**YUCCA MOUNTAIN
SITE CHARACTERIZATION
PROJECT**

**EXTENDED SUMMARY REPORT
ON
ENGINEERED BARRIER SYSTEM CONCEPTS
WORKSHOP
JUNE 18-20, 1991
DENVER COLORADO**

OCTOBER 1991

Figure 2

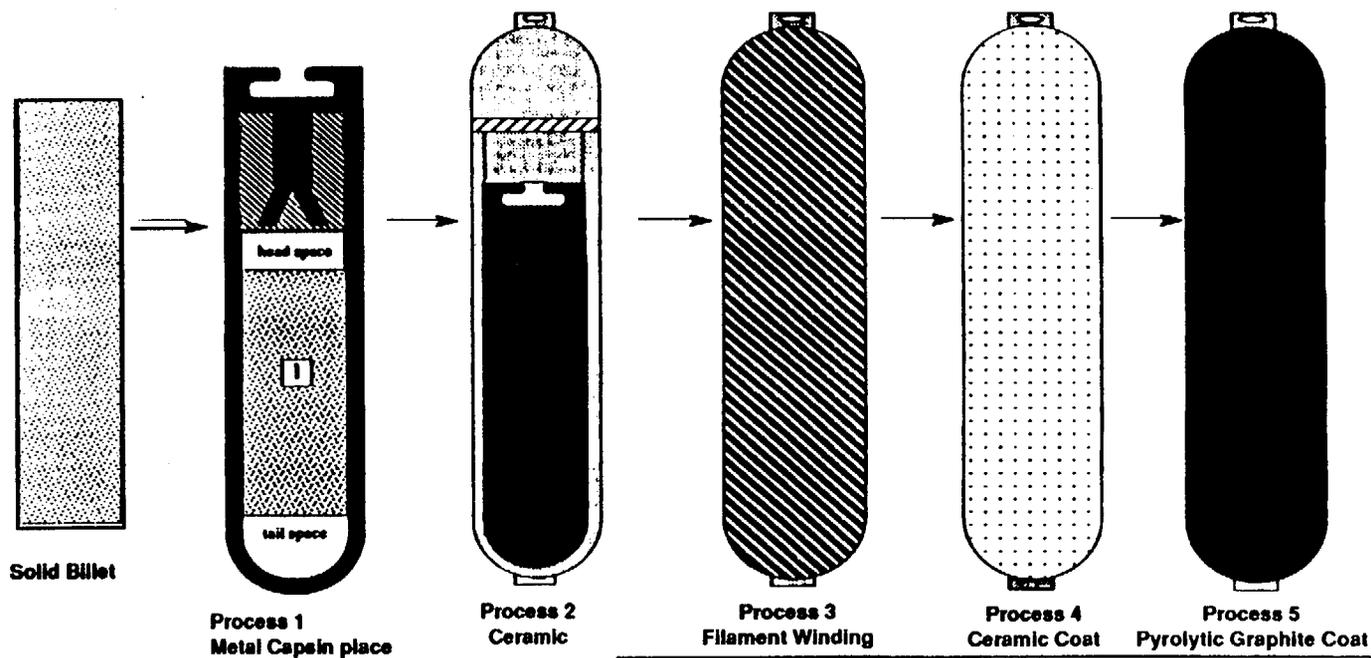
The multi-layer approach increases the redundancy of the package. Containment is provided initially by the inner metal container. The ceramic overcoat protects the metal container and provides increased strength. The filament winding is to provide additional strength to the ceramic. The zirconium cement makes the package as impervious as possible and the pyrolytic graphite provides an additional seal which can withstand very high temperatures.

Figure 6

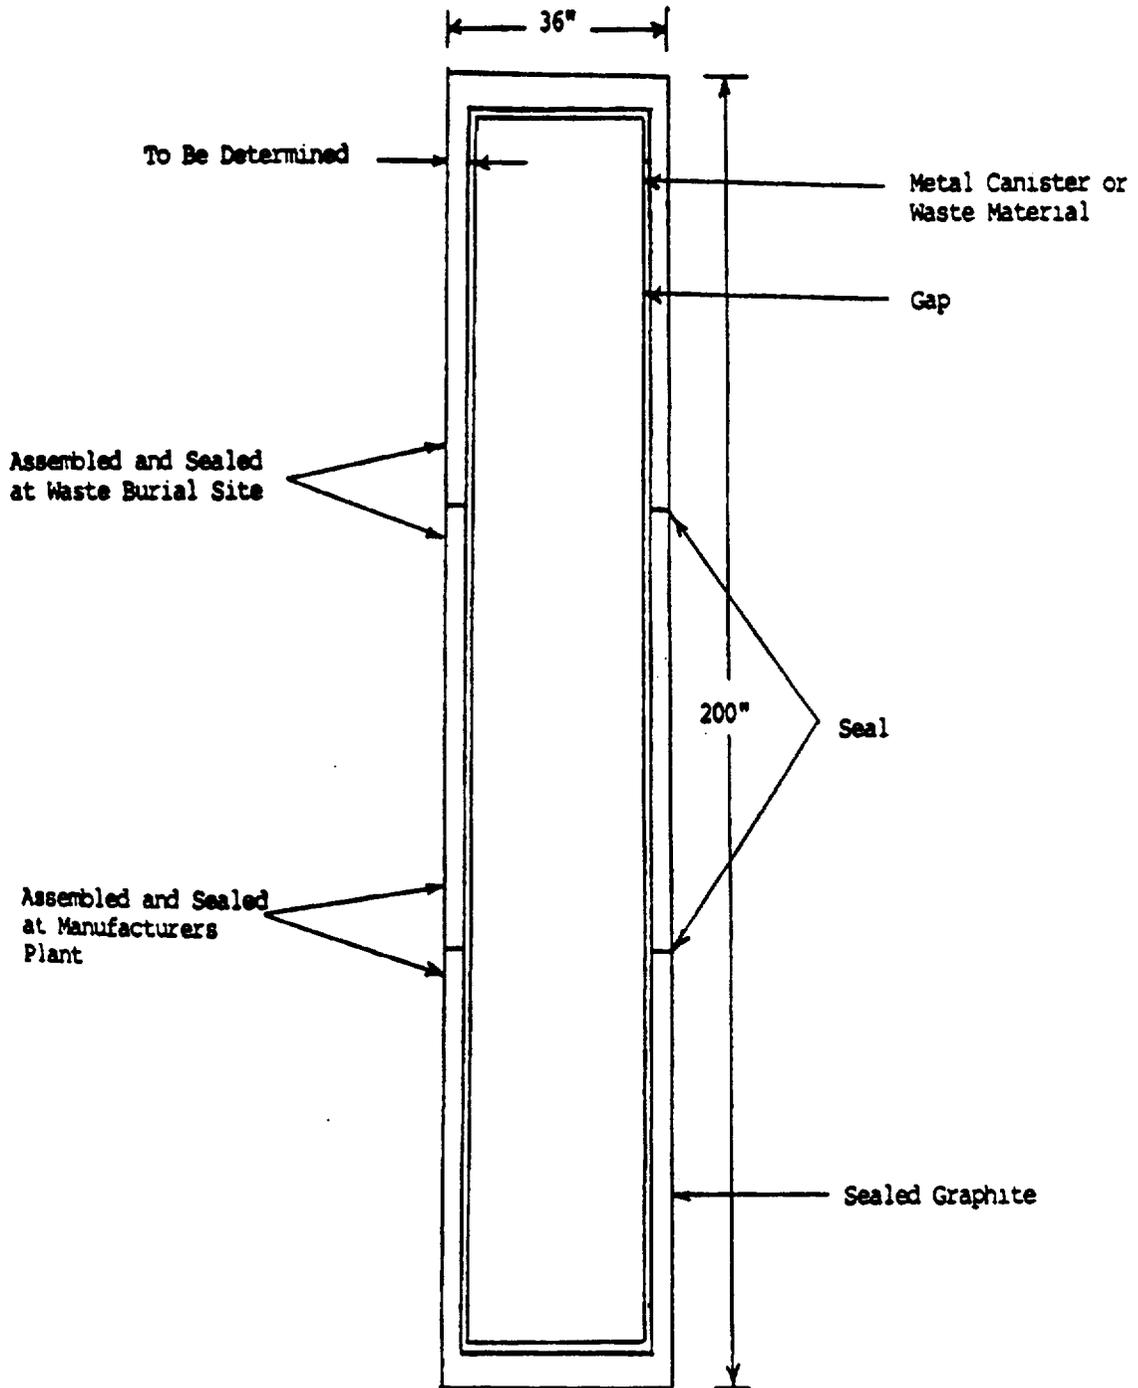
Criticality may be a problem. (Van Konyenburg) Response was that boron could be put in to take care of the criticality question.

Heating the fuel to 550°C for short periods may not be harmful. (Einziger)

Figure 7

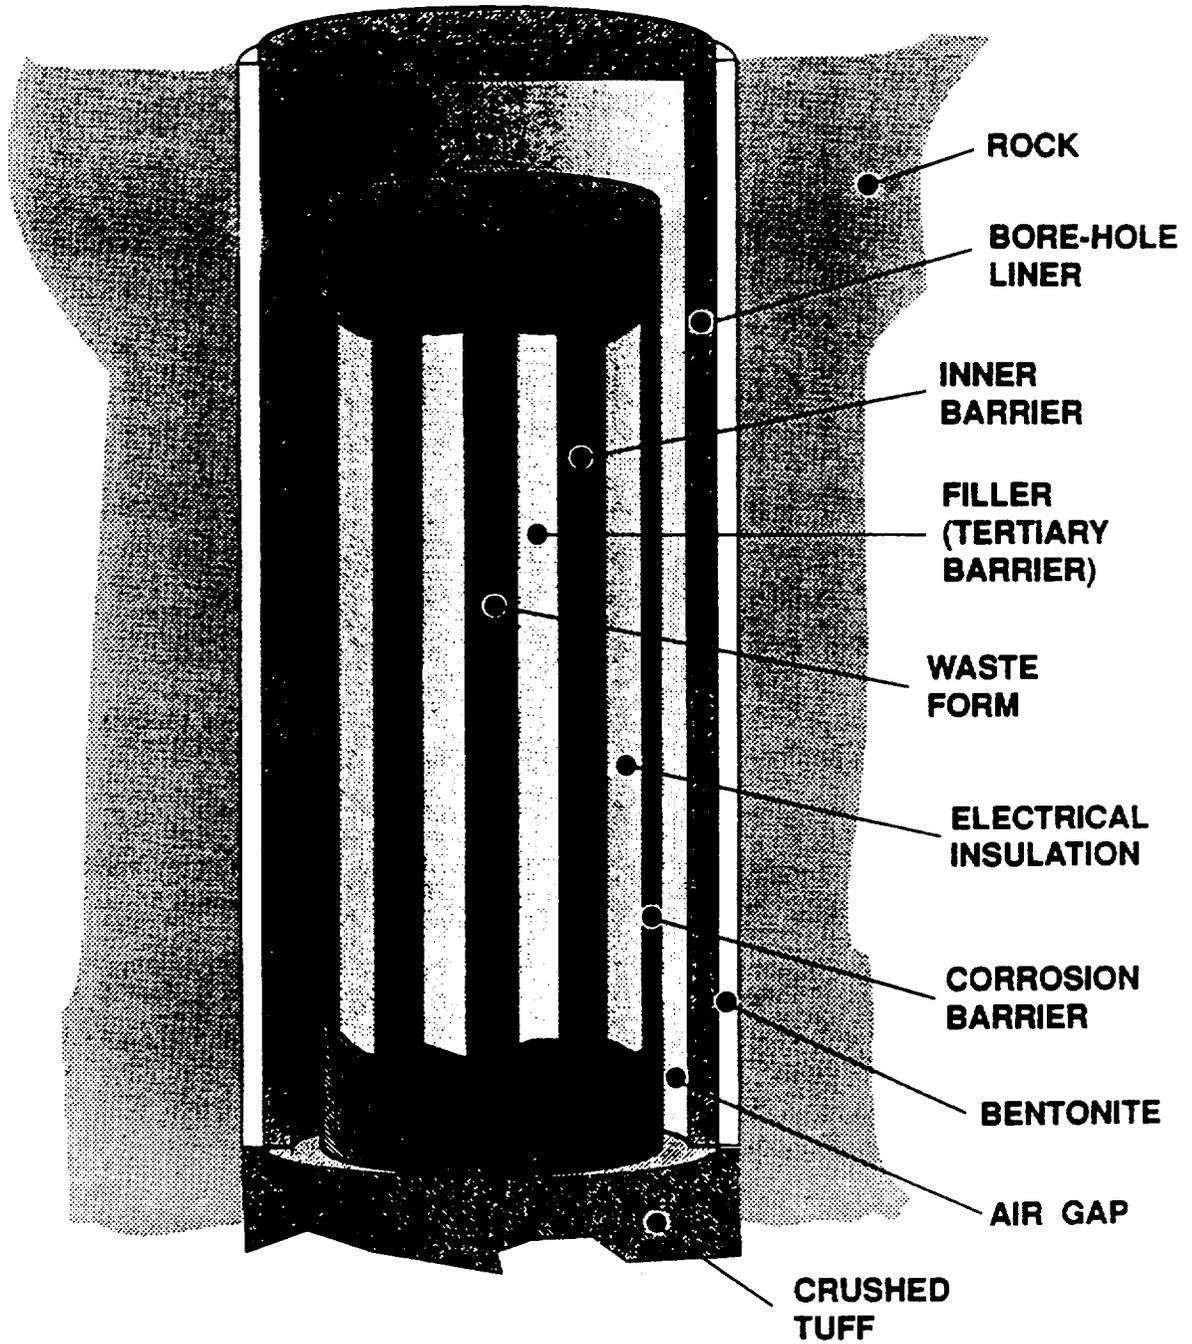
Closure may be a problem. (Andresen) Response was that closure is not simple, and that friction welding is preferred.

Titanium has a lot of merit. It forms a protective film which is not a good cathode to steel. (Staehle)

Figure 10

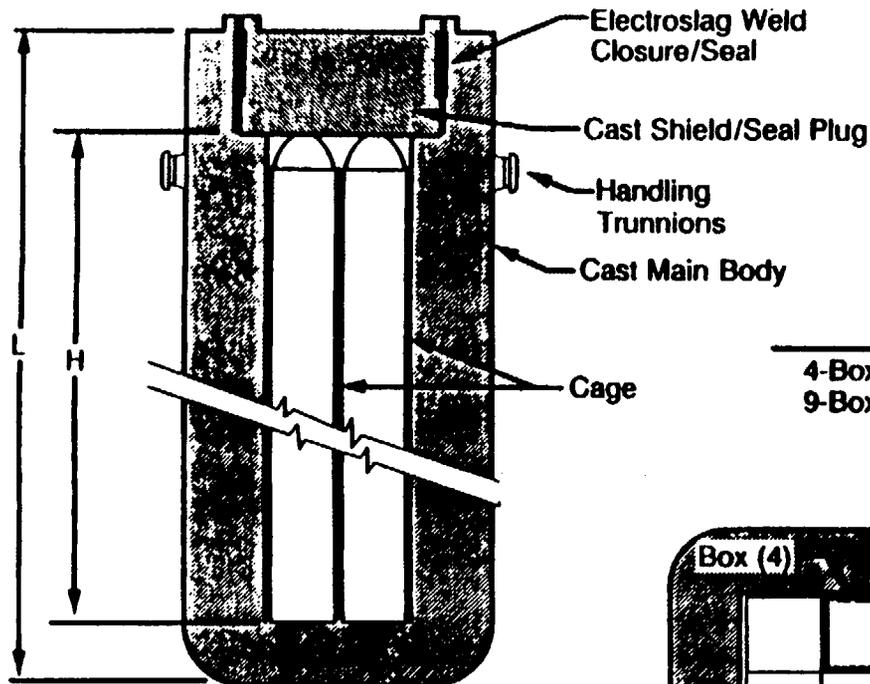
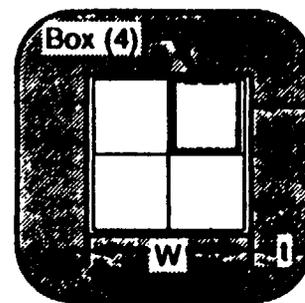
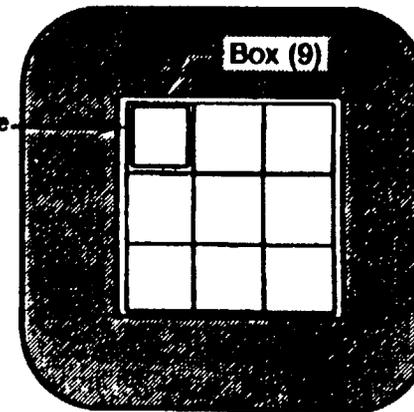
If breaching of the wall occurs by corrosion, the game is over for the container, and the mechanism for further failure will change. (Shoesmith)

Brittleness may be a problem; thus, Duriron may be a better material, especially because of its better corrosion resistance compared to cast gray iron. Higher chromium steels may also improve corrosion resistance. Also, the environment could be modified (such as adding limestone) to reduce corrosion of steel. (Staeble)

What to surround the steel with and how long it will sustain the pH are interesting technical questions that would have to be resolved. (Staeble)

Engineering the environment is not an easier problem than engineering the waste package. You must ensure that the modified environment survives for very long times. (Halsey)

Figure 11

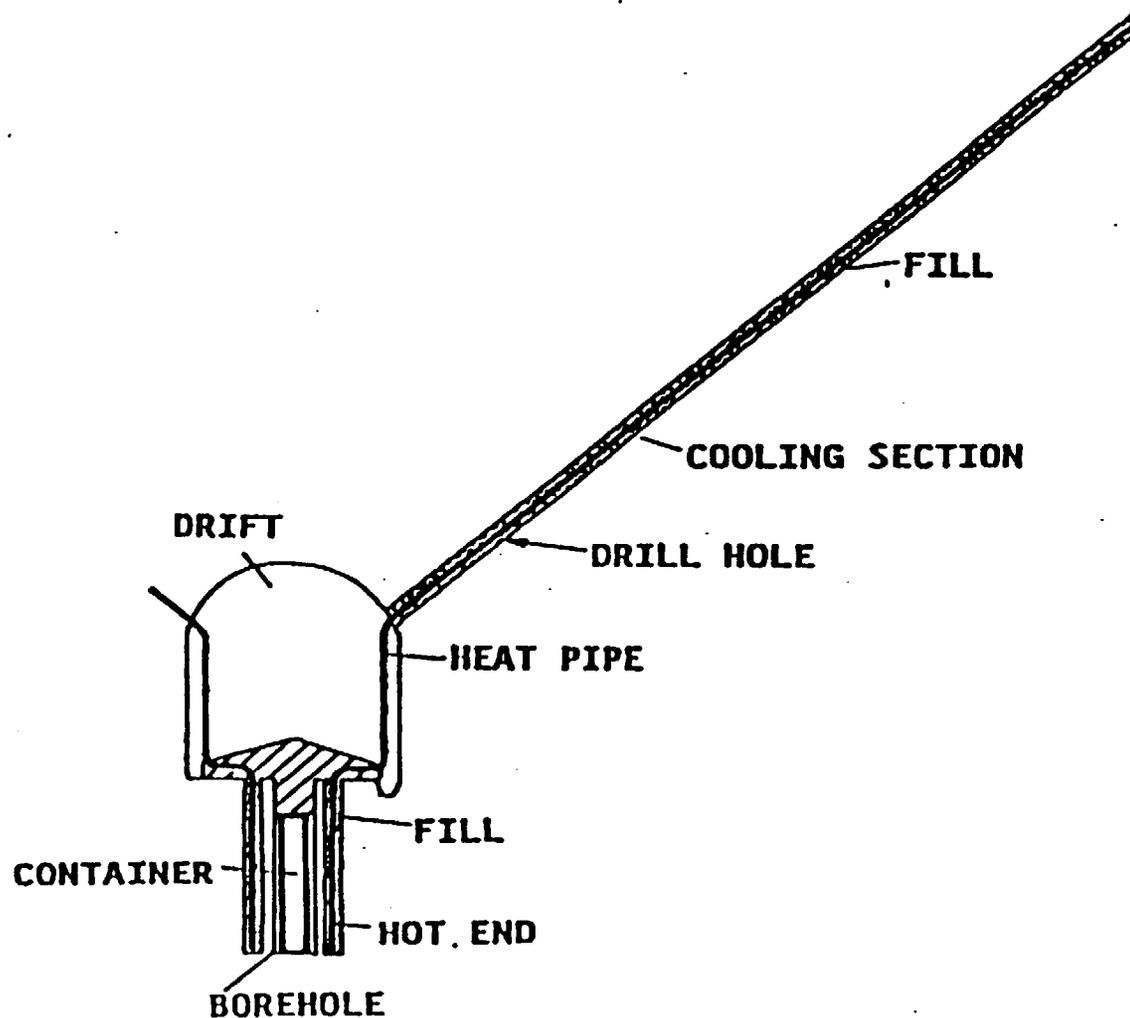
The life and reliability of these devices are questionable.

Carbon steel pipes fail due to internal corrosion, with hydrogen bubble formation. (Miglin) Response was that copper, rather than steel, would be used.
